## REFERRAL REPORT

TO: Vancouver City Council  
FROM: General Manager of Planning, Urban Design and Sustainability  
SUBJECT: CD-1 Rezoning: 4408-4488 Fraser Street and 707-709 East 29th Avenue

Proposed Upper Townhouse Floor

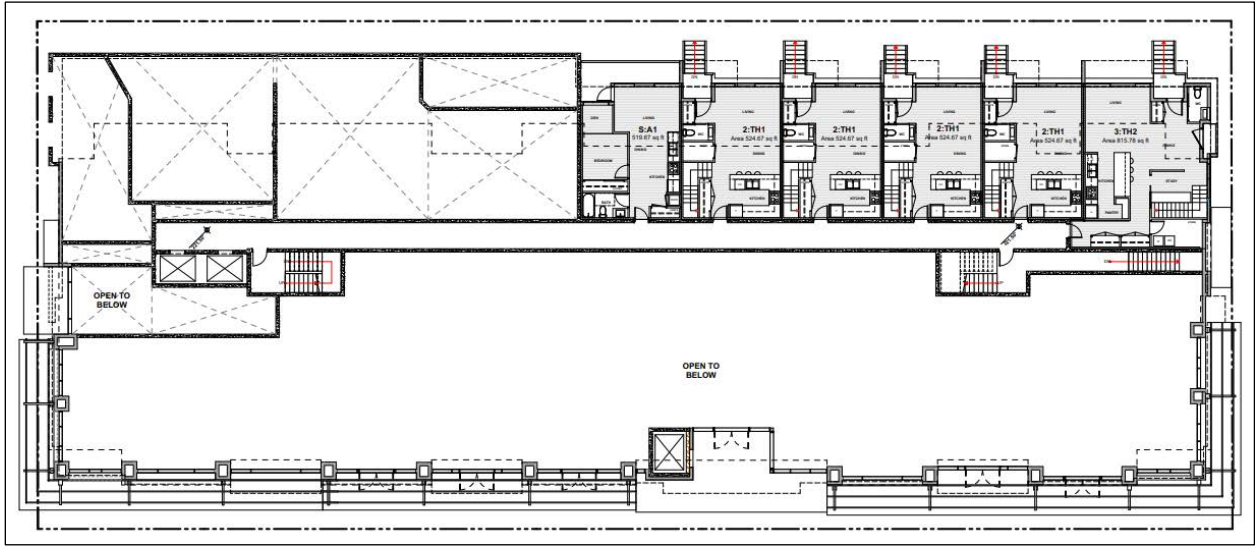
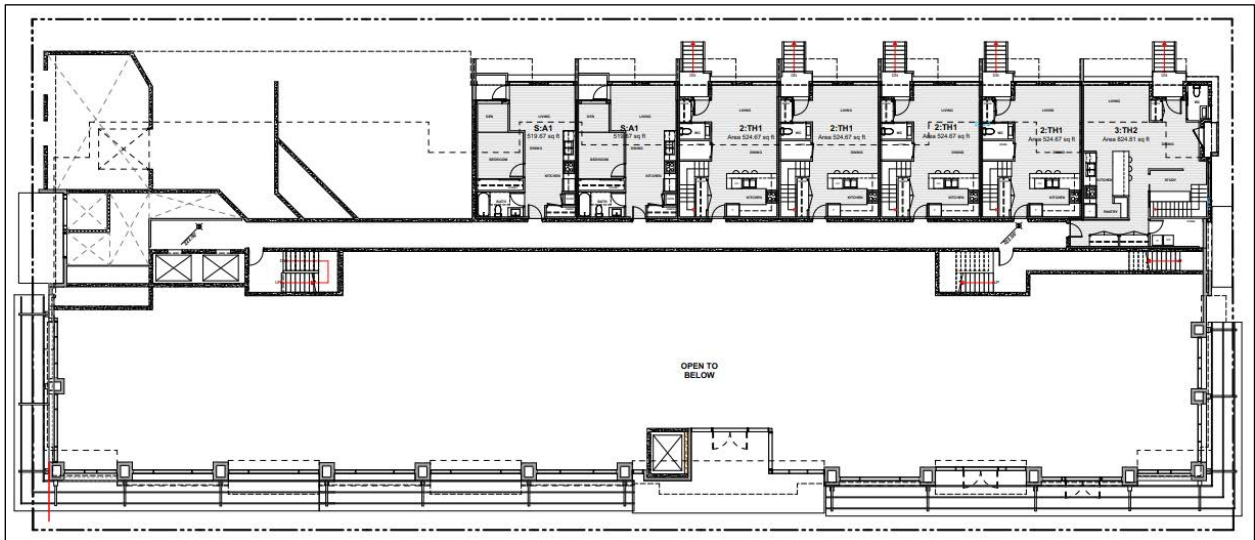
To accommodate larger amenity areas, staff recommend the relocation of the indoor amenity from the roof to another floor within the building. As indoor amenity areas are included in building height calculations, the change would result in reducing the building height from 24.1 m (79.1 ft.) to 21.6 m (70.9 ft.). The roof-top elements would be limited to access to an outdoor amenity area and mechanical/elevator elements, all of which are permitted height exclusions as

Recommended Upper Townhouse Floor
